Access Compliance Report Public Rights-of-Way (Curb Ramps)

Main Street: **OSO_PKWY** Cross Street: **LOS_PATRONES_PKWY** Location: **SE**

ADA ID: **RPRK211021121351** Ramp Type: **Type 1 - Perpendicular Diagonal** Initial Pass/Fail: **Pass** Overall Compliance: **No** Severity Score: **2**

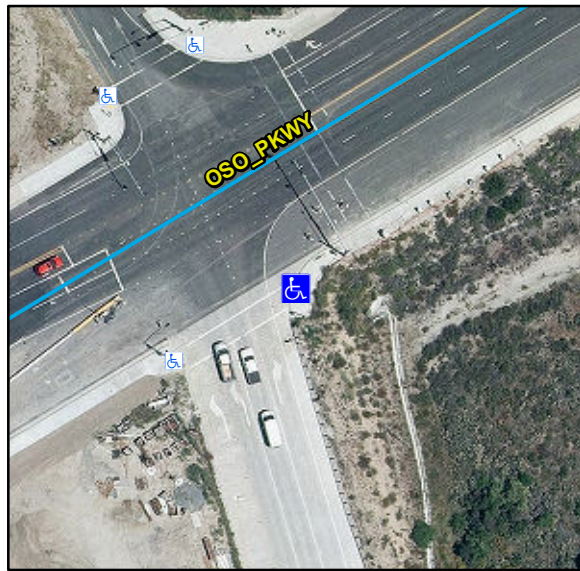
Compliance	Description	Data	Compliance	Description	Data
N/A	Ramp Length (in)	86	N/A	Flare Type LT	
Yes	Ramp Width (in)	48			Sloped
Yes	Ramp Run Slope (%)	5.2	Yes	Flare Slope LT (%)	5.1
No	Ramp Cross Slope (%)	2.5	N/A	Flare Traversable LT	Yes
N/A	Landing Present	Yes	N/A	Flare Type RT	
N/A	Landing Length (in)	49			Sloped
Yes	Landing Width (in)	48	N/A	Flare Slope RT (%)	1.4
Yes	Landing Run Slope (%)	1.2	N/A	Flare Traversable RT	No
Yes	Landing Cross Slope (%)	0.7	Yes	DWS Provided	Yes
N/A	Landing Movement Obstructed?	No	Yes	DWS Contrast	Yes
	Landing Movement Type	N/A	Yes	DWS Length (in)	36
N/A	Landing Shared	No	Yes	DWS Full Width	Yes
N/A	Clear Space	Yes	Yes	DWS Offset Left (in)	0
N/A	Clear Space To Crosswalk (in)	48	Yes	DWS Offset Right (in)	N/A
N/A	Marked Crosswalk 1	No	N/A	Marked Crosswalk 2	Yes
	Crossing 1 Direction	N		Crossing 2 Direction	W
	Marked Crosswalk 1 Width (in)	N/A		Marked Crosswalk 2 Width (in)	144

Remove & Replace Curb Ramp With Two New Directional Ramps or Equivalent.
